**ADDENDUM #6  
MAY 23, 2024**

**REQUEST FOR TENDER FOR  
REGIONAL LANDFILL CELL 5 NORTH CONSTRUCTION  
CONTRACT 9-2024 APRIL 2024  
ESSEX-WINDSOR SOLID WASTE AUTHORITY**

Please be advised that this **Addendum #6** is provided to inform the plan takers of the following responses to questions, and revisions to the tender package:

PROJECT NO. 111-53107-10	CONTROL 2001	REV. B	28 of 29	DRAWING E01
-----------------------------	-----------------	-----------	----------	----------------

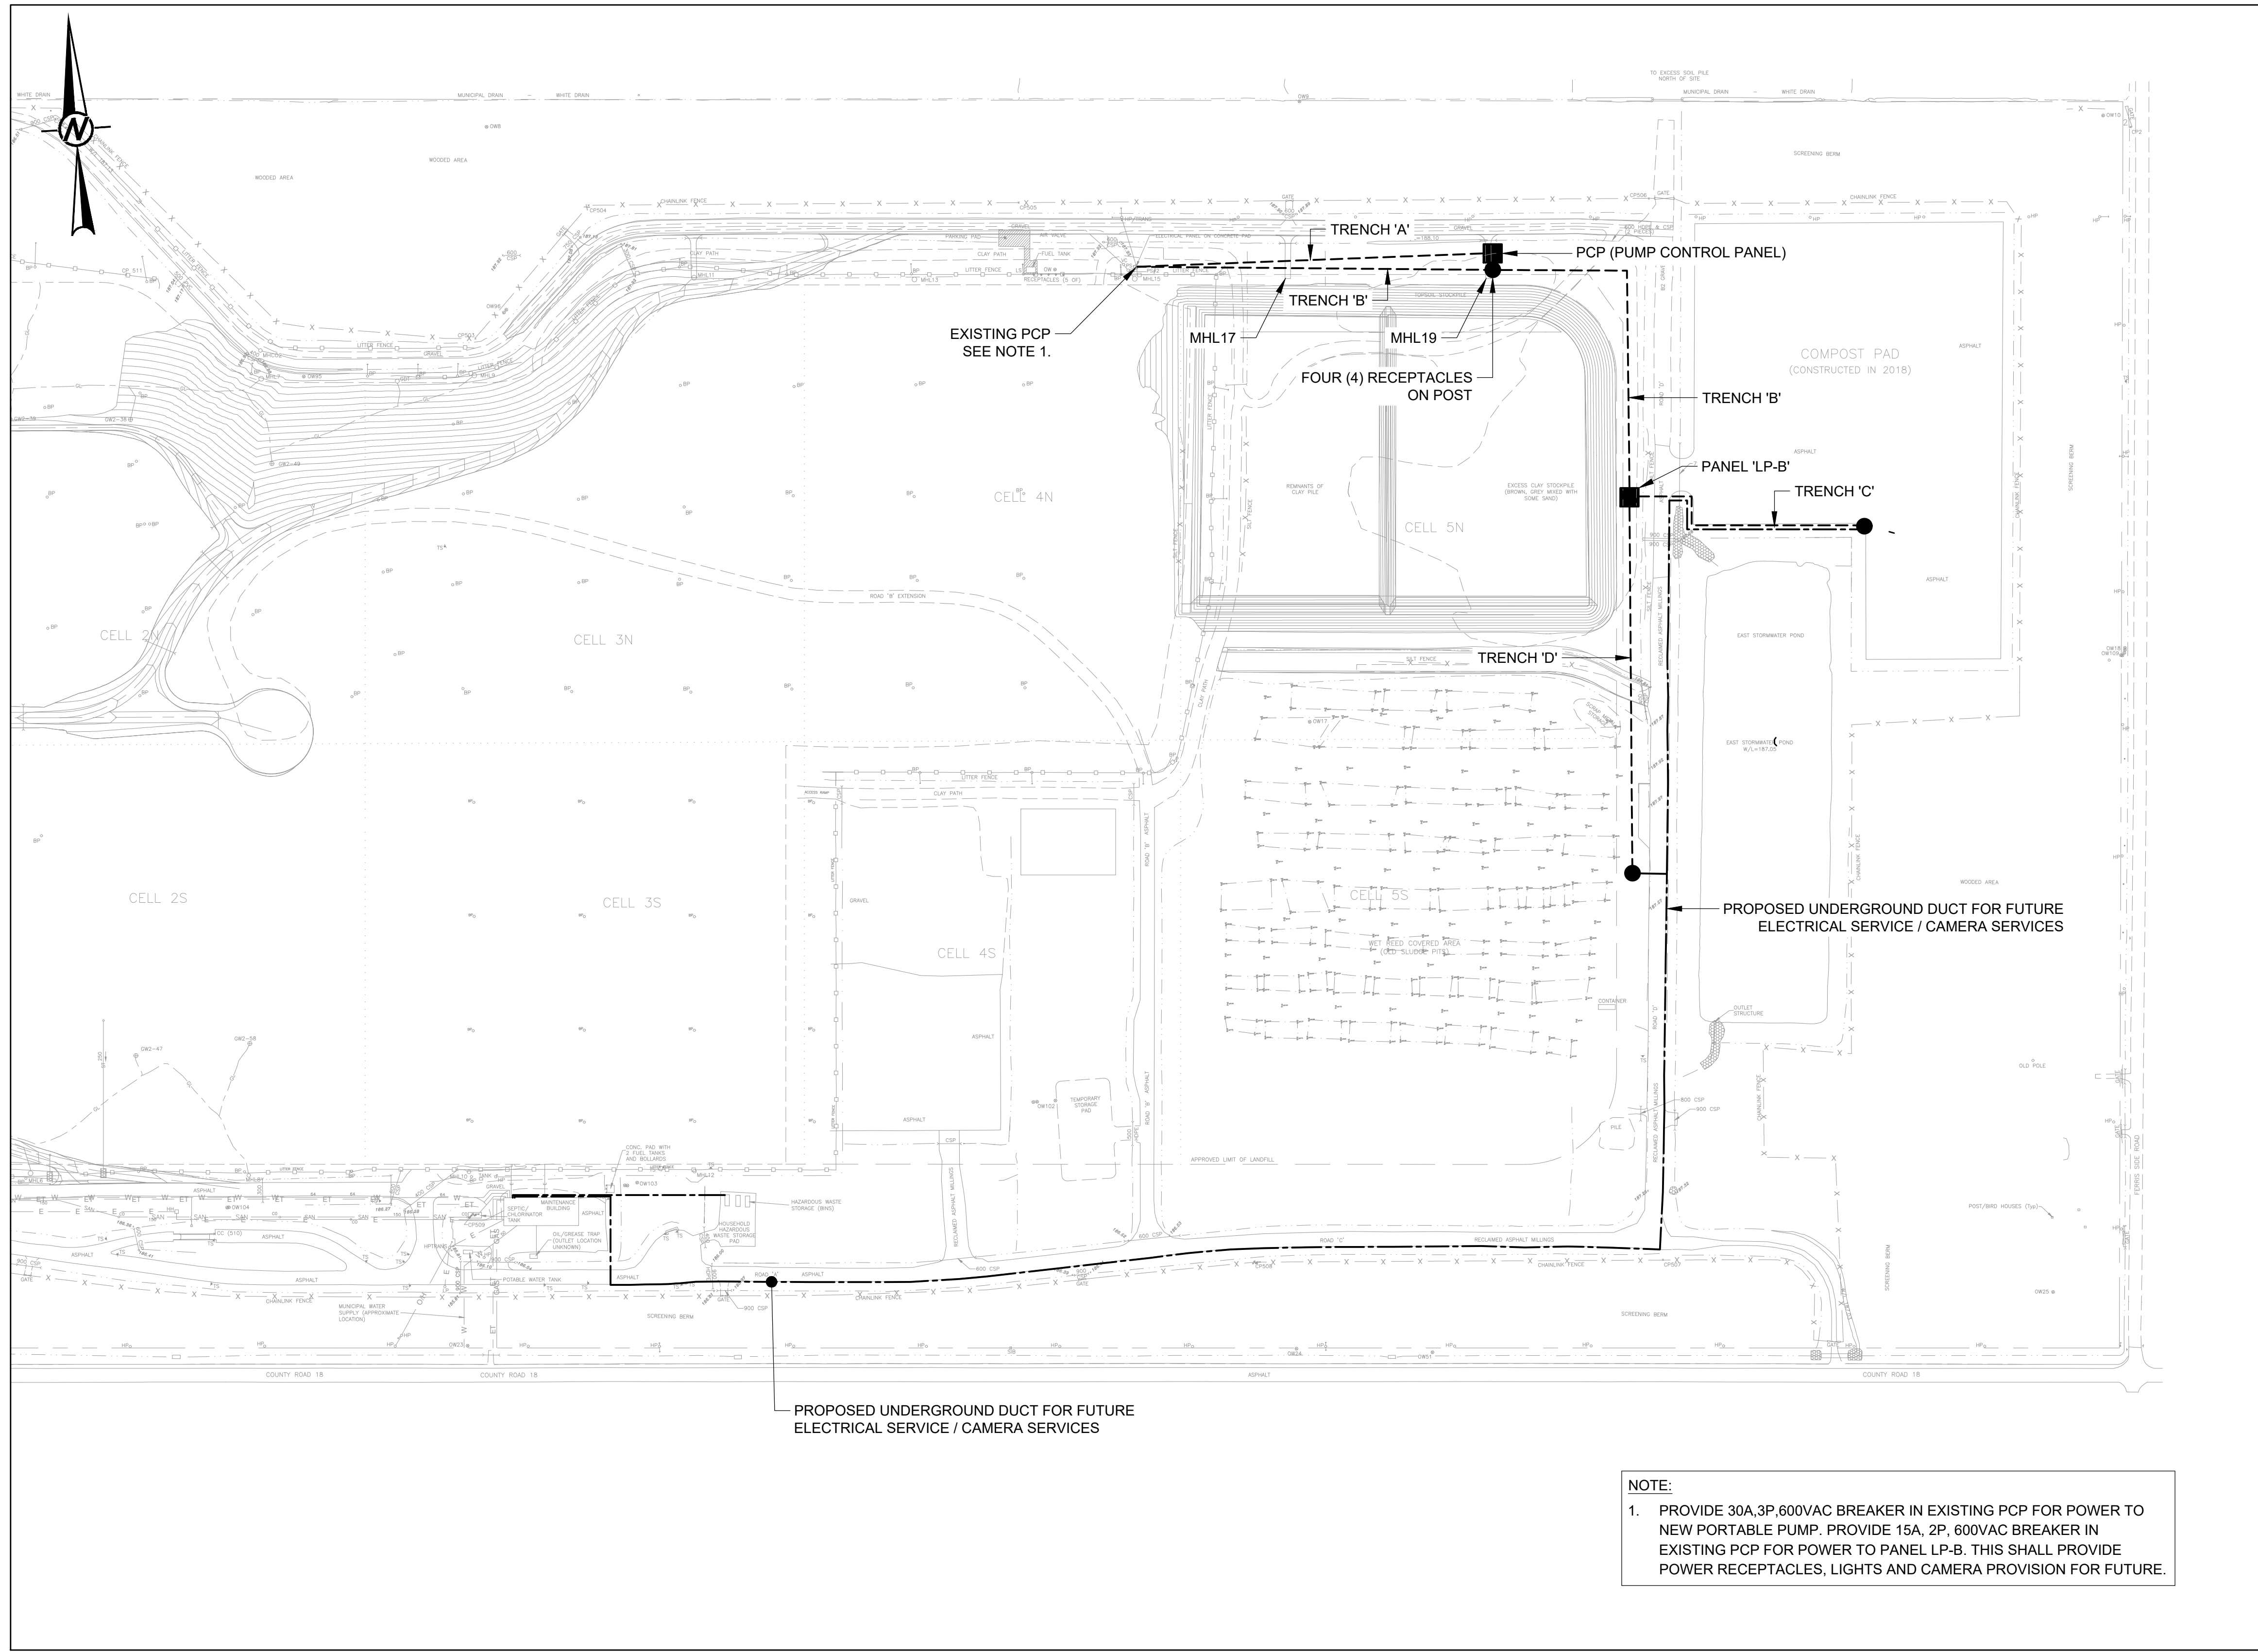
1. Question 1: There is no current LPB in the location shown on the drawing, please clarify?

3. Question 3: On site contact feels there are cameras in at least three locations; compost pad, scrap metal storage and hazardous waste area. Please confirm?

6. Question 6: Drawing E01 labelled varied electrical trench names (i.e., Trench 'A', etc.). Please provide details for each Trench Name label. How many ducts, Size of ducts, etc.? Are they all same detail as "Secondary Ducts" as shown on drawing E02?

1. The data conduit layout has been updated to allow for an extension across the existing east perimeter to the southwest corner of the new truck clean out area. The updated drawings showing this change are attached.
2. The following Drawings have been updated and are attached to this addendum: Drawings E01 and E02.
3. The contract Working Day Limit is now increased from **130 to 160 days** to allow for the additional work outlined in the issued addendums. Please note that any reference to the Working Day Limit in any issued tender package document is hereby increased from **130 to 160 Working Days**.

*Response: Panel LP-A and Panel LP-B are new and are to be provided as part of this project tender.*

*Response: Conduits as shown on site plan are to be provided for future use by the owner. No cameras are to be provided by the contractor. Any additional work will be addressed by a change order for the selected contractor.*

*Response: Yes, each trench shown on Drawings E01 and E02 share the same construction details. Each trench contains a total of 4 ducts with an inner diameter of 2 inches. Please see the updated Drawings.*

**PCP 3 SINGLE LINE DIAGRAM**

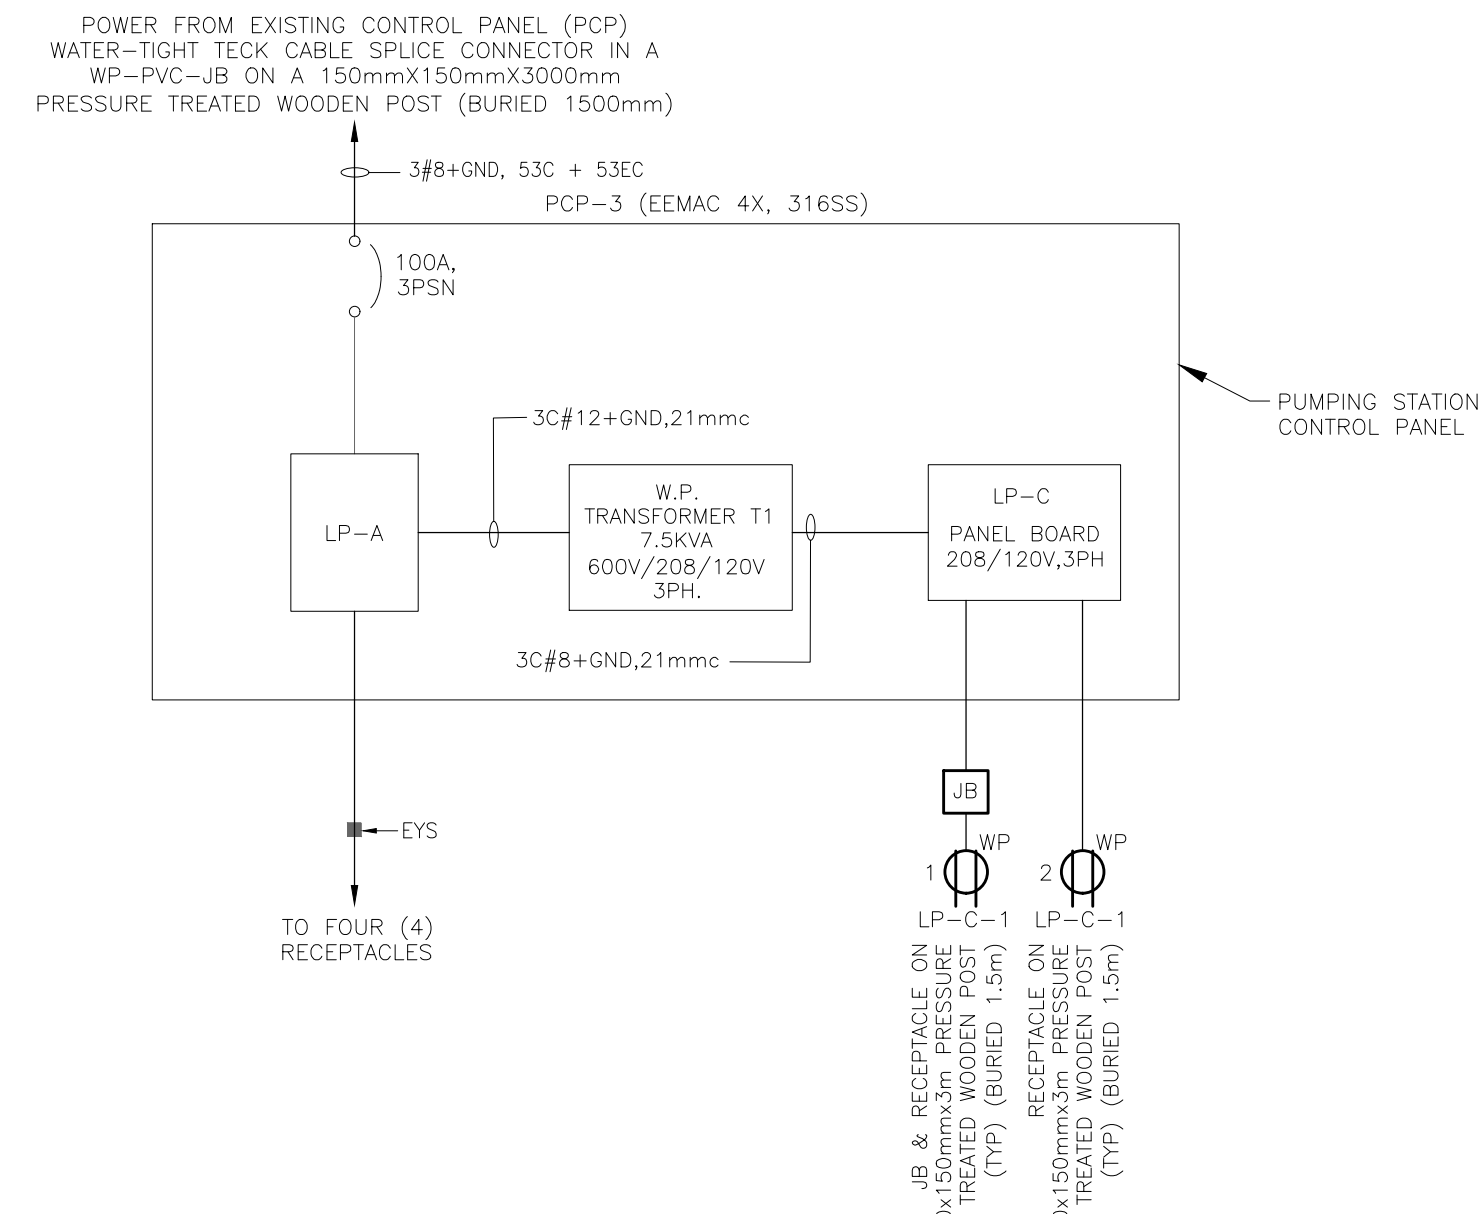
4. Question 4: What type of 600-volt receptacles are required from panel LP-A?

*Response: Receptacles as per drawings and are 600V AC, 3 phase, additional stepdown transformer shall be added for single phase 220V AC pumps. Drawings are updated as attached to this addendum.*
